## SB, Deck/pivot block damage, Lawnmower, Powermax 36 E, Powermax 42E, 2011-04

### Service information:

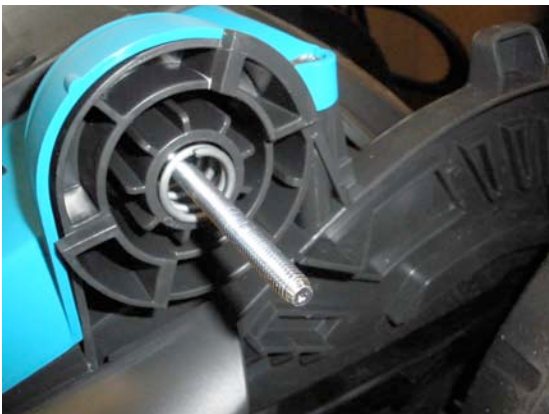
To eliminate customer returns regarding deck damage to pivot block/handle area. The solution was to design an insert made from glass filled nylon & fit to deck pivot block area, re-design the pivot block to interface with insert this eliminates damage to PP deck.

Cam lock profile modified to aid customer regarding adjustment

Old Part No: Pivot block 5052548-02, Cam lock 5052551-03

New Part No: Pivot block 55773425-02, Cam lock 5771347-01, Pivot block insert 5777281-68

Due to tuning of the deck to enable inserts to fit correctly & because these modifications had no effect on current products the deck part number did not change.
